# Access Compliance Report

## Public Rights-of-Way

Intersection ID: 28184	Main Street: BLAKENEY_HEATH_RD	Cross Street: BLAKENEY_PROFESSIONAL_DR	Location: NW
ADA ID: 062932AB92CD	Ramp Type: ParaDiag	Initial Pass/Fail: Fail	Overall Compliance: No
Severity Score: 26.25			
Codes/Mitigation Info/Possible Solution		Field Measurements/Component Compliance

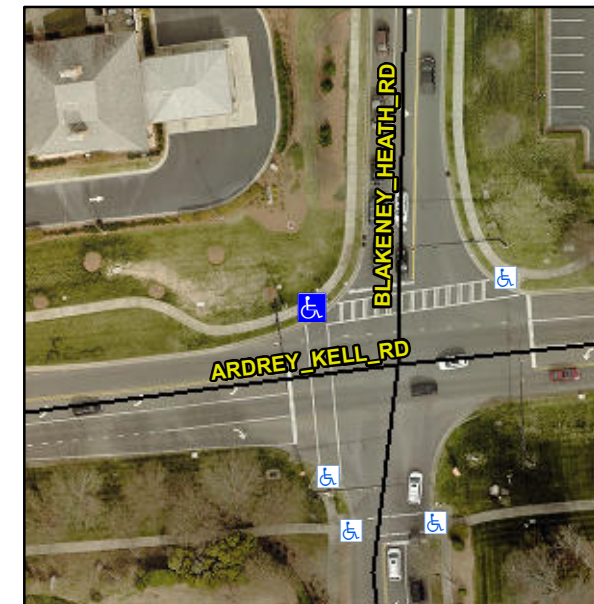
**RT RP < 5%**

**R304.3.2, R304.5.3**

Compliance	Description	Data	Compliance	Description	Data
N/A	Ramp Length LT (in)	57.0	N/A	Ramp Length RT (in)	54.0
Yes	Ramp Width LT (in)	57.0	Yes	Ramp Width RT (in)	57.0
No	Ramp Slope LT (%)	13.2	Yes	Ramp Slope RT (%)	2.5
No	Ramp XSlope LT (%)	2.5	No	Ramp XSlope RT (%)	3.1
N/A	Landing Length (in)	N/A	N/A	DWS Provided?	N/A
N/A	Landing Width (in)	N/A	N/A	DWS Contrast?	N/A
N/A	Landing Slope (%)	N/A	N/A	DWS Length (in)	N/A
N/A	Landing X Slope (%)	N/A	N/A	DWS Full Width?	N/A
N/A	Landing Curb? (Y/N)	N/A	N/A	DWS Offset (in)	N/A
N/A	Shared Landing?	N/A			
N/A	Gutter Ponding?	N/A	N/A	Gutter Slope (%)	N/A
N/A	Gutter Lip Ht (in)	N/A	N/A	Gutter X Slope (%)	N/A
N/A	Painted X Walk1?	Yes	N/A	Painted X Walk2?	Yes
	X Walk 1 Direction	To S		X Walk 2 Direction	To E
N/A	X Walk 1 Width (in)	126.0	N/A	X Walk 2 Width (in)	113.0
	X Walk 1 Slope (%)	1.9		X Walk 2 Slope (%)	2.0
	X Walk 1 X Slope (%)	1.0		X Walk 2 X Slope (%)	0.1
N/A	Ramp inside XWalk1?	Yes	N/A	Ramp inside XWalk2?	Yes

**Remove & Replace Curb Ramp With Two New Directional Ramps or Equivalent.**
